**SAN ANTONIO WATER SYSTEM
CENTRAL WATER INTEGRATION PIPELINE
MALTSBERGER TANK REHABILITATION PROJECT
SAWS Job No. 18-8611
SAWS Solicitation No. CO-00183**

**ADDENDUM No. 2
July 19, 2018**

D-2105

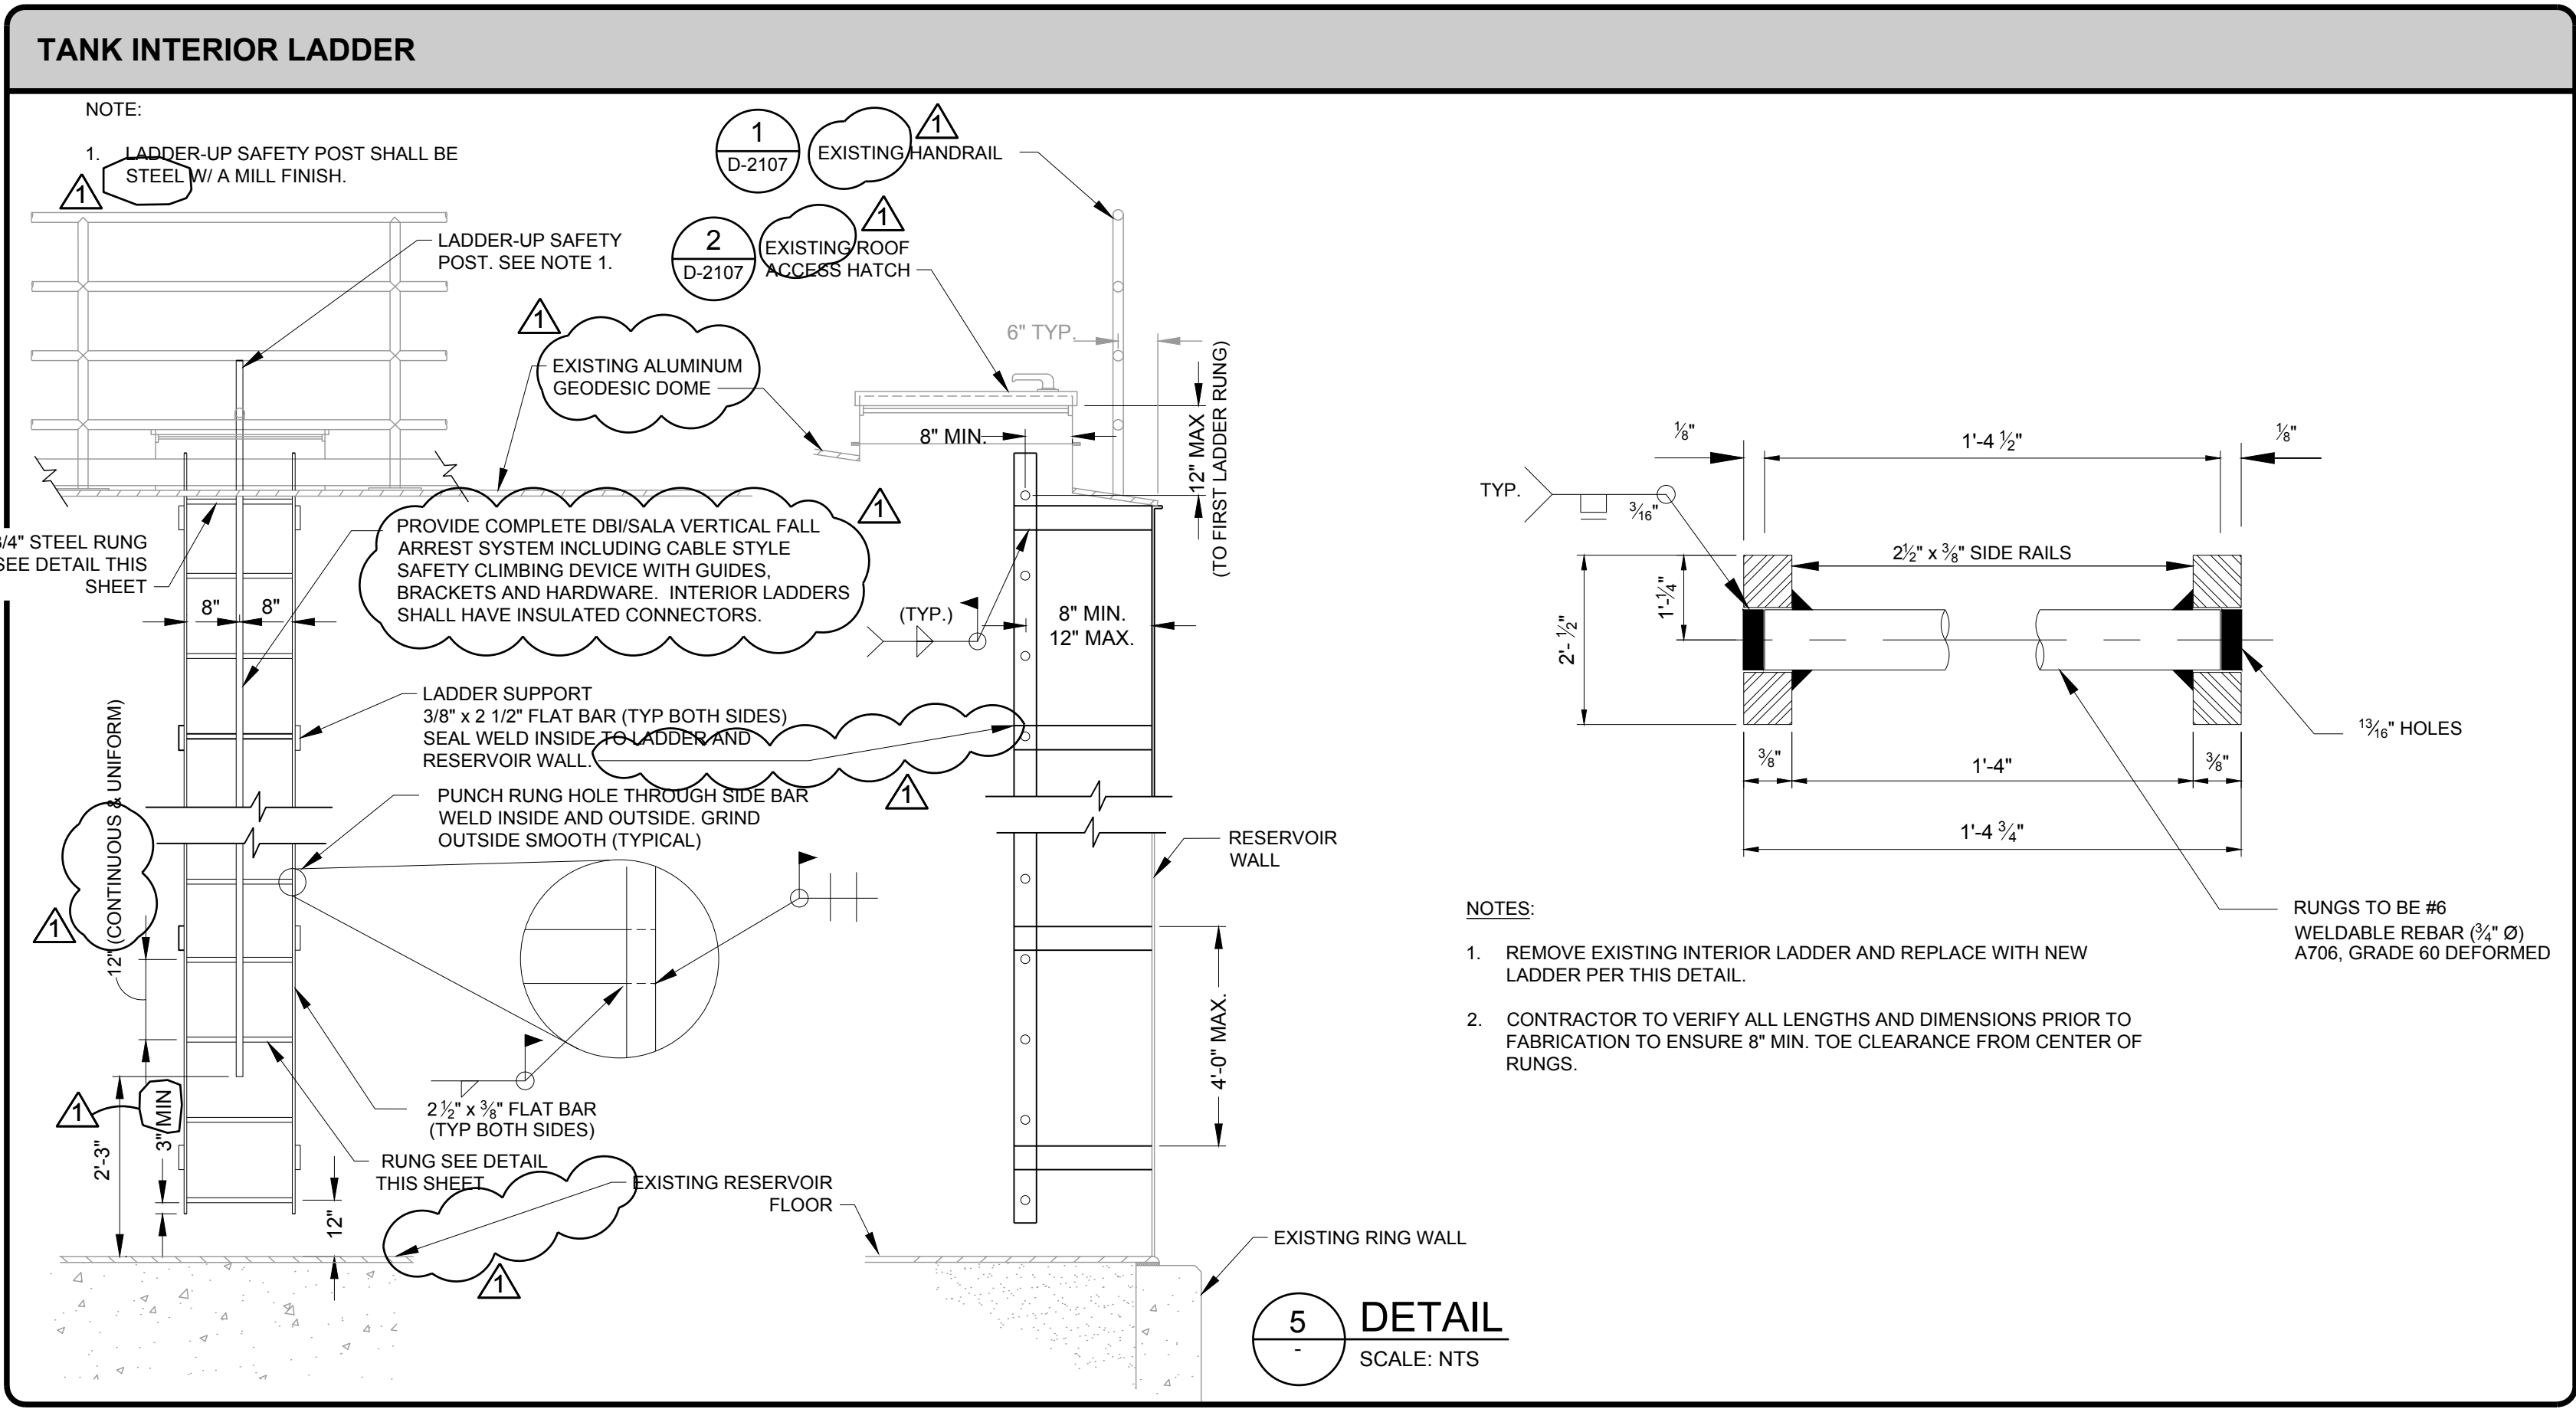
- a) Remove Sheet D-2105 in its entirety and replace with the revised version included in this Addendum. Detail 3, 48” Outlet Pipes, has been updated to indicate that the existing outlet butterfly valves will remain intact and that a temporary plug will be installed on these lines.

- NOTES:
1. PLUG EXISTING OUTLET PIPE W/ PETERSEN MULTI-FLEX HIGH PRESSURE LINE STOP PLUG PART #129-048 TO SEAL AGAINST POSSIBLE NON-SEALING VALVE.

3 DETAIL
SCALE: NTS

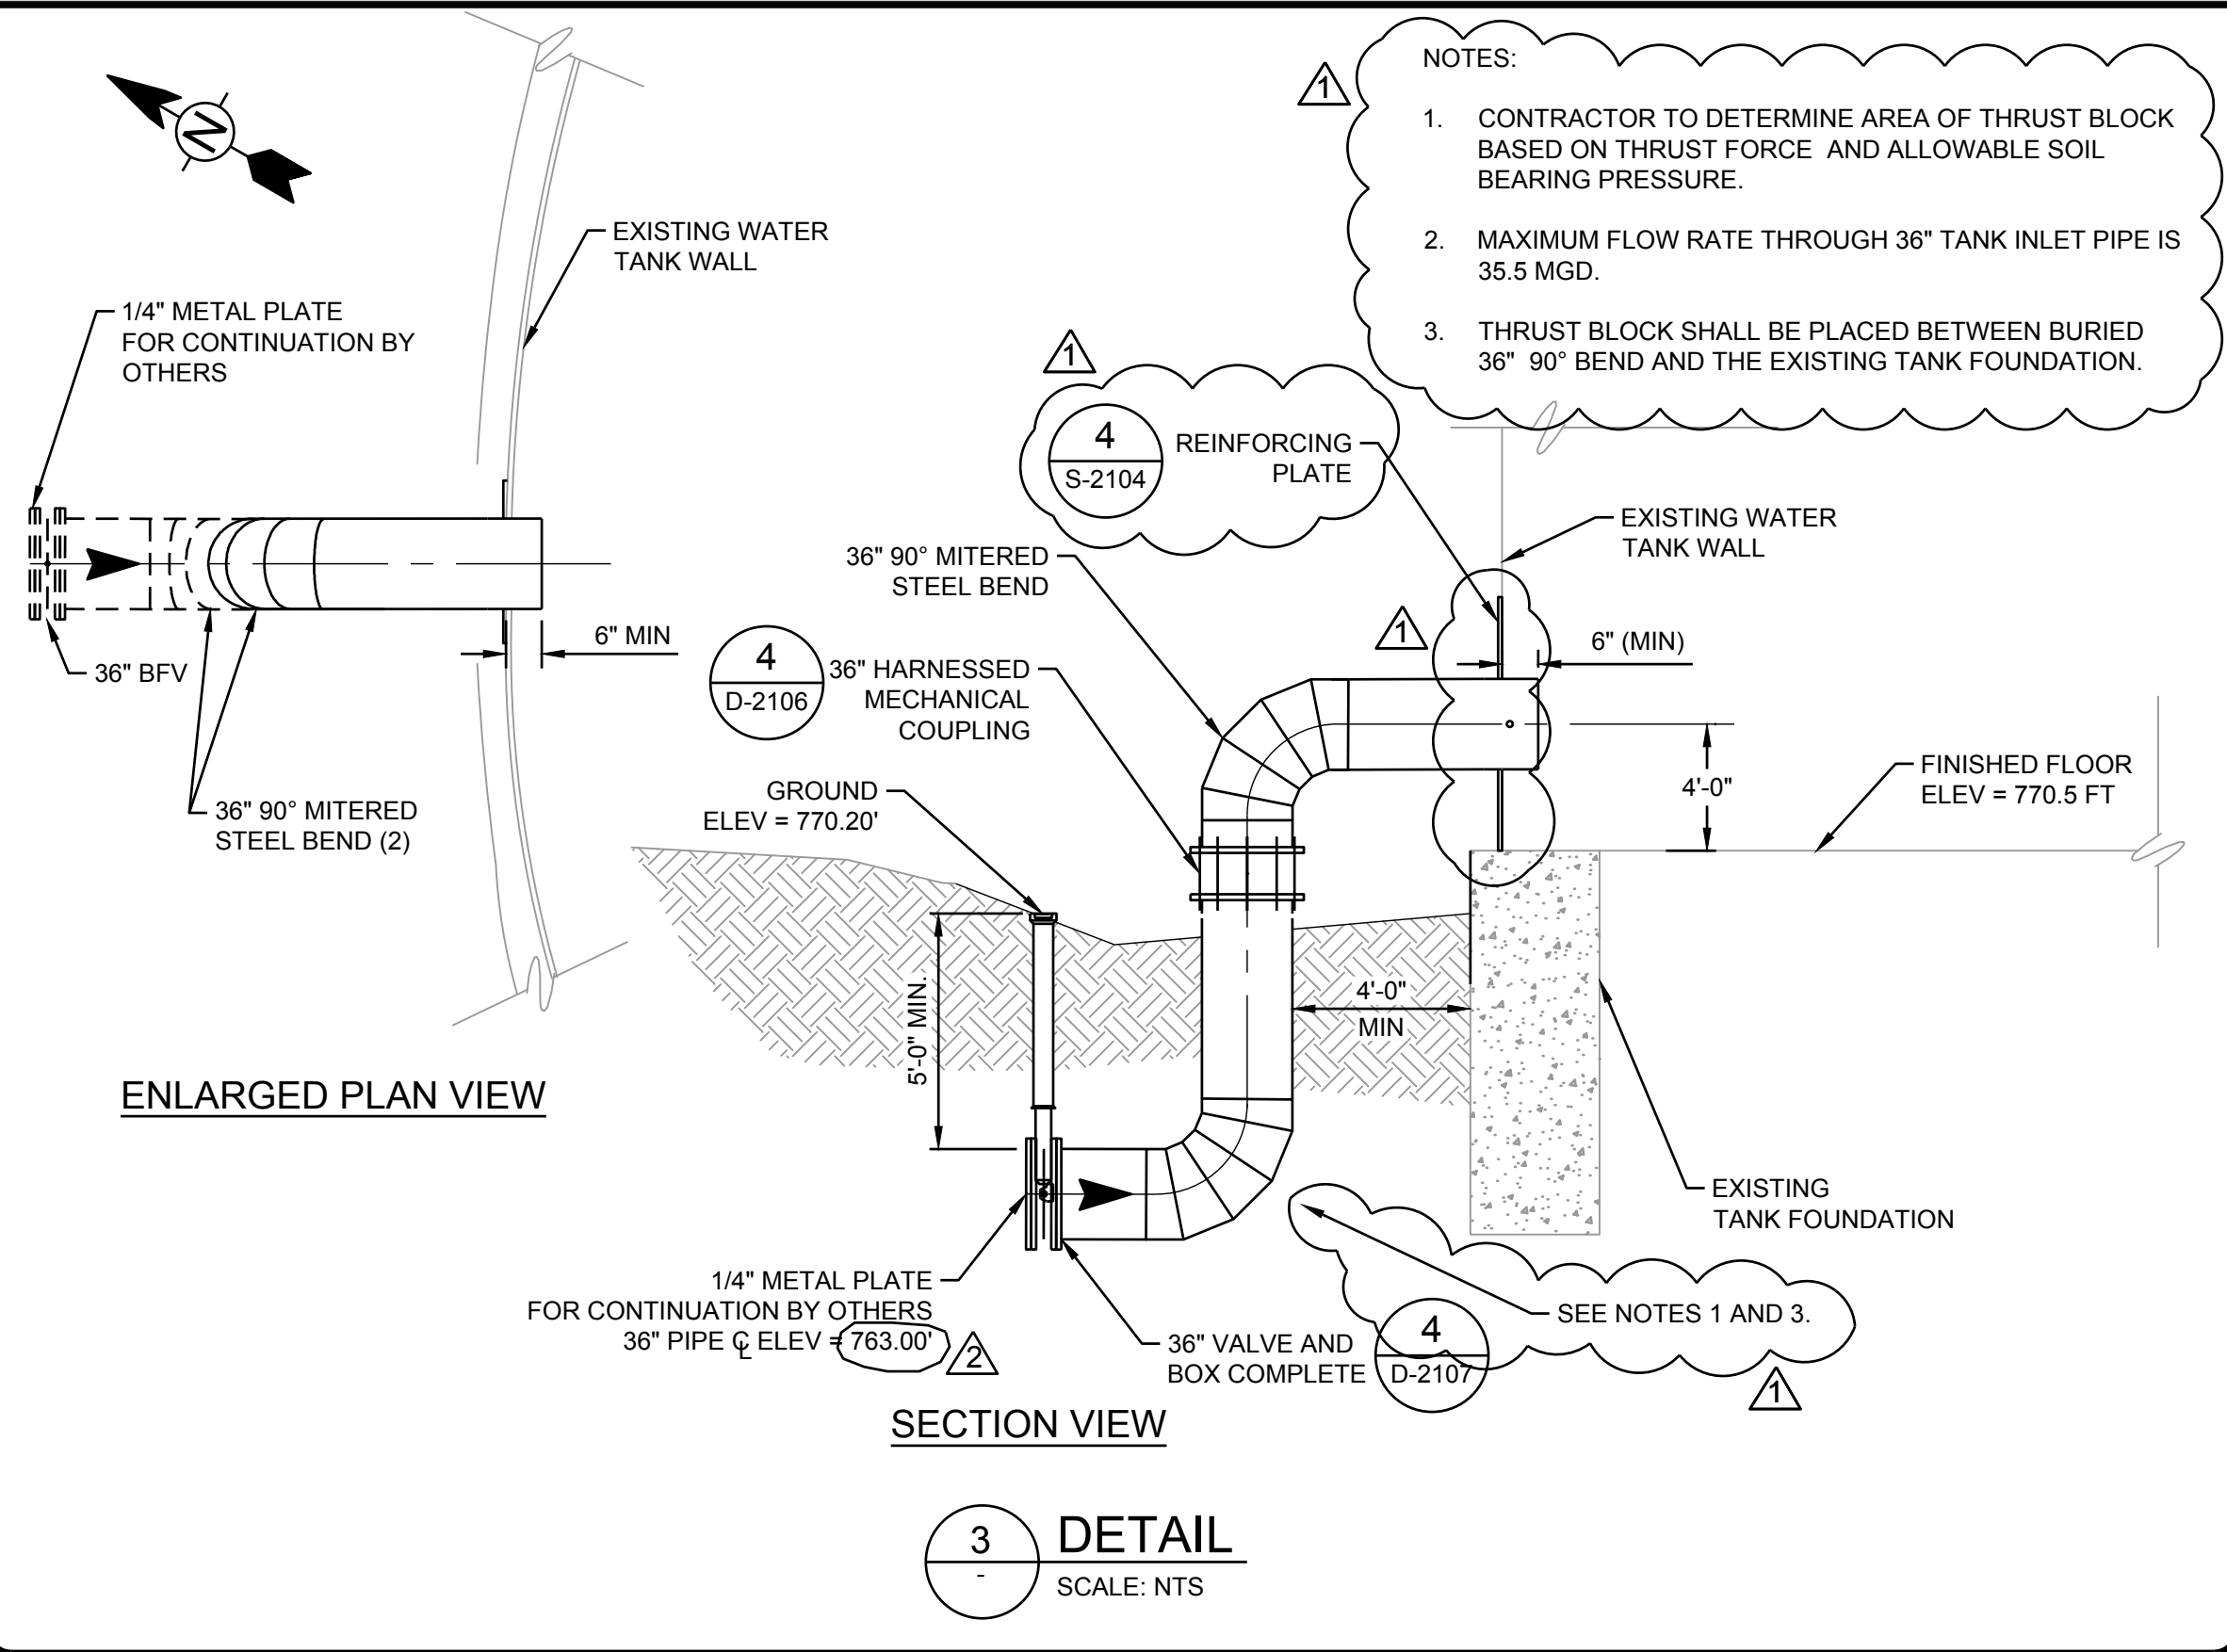
- a) Remove Sheet D-2108 in its entirety and replace with the revised version included in this Addendum. In Detail 3, 36" Tank Inlet (Sidewall), the centerline elevation of the below grade 36-inch inlet pipe has been updated.
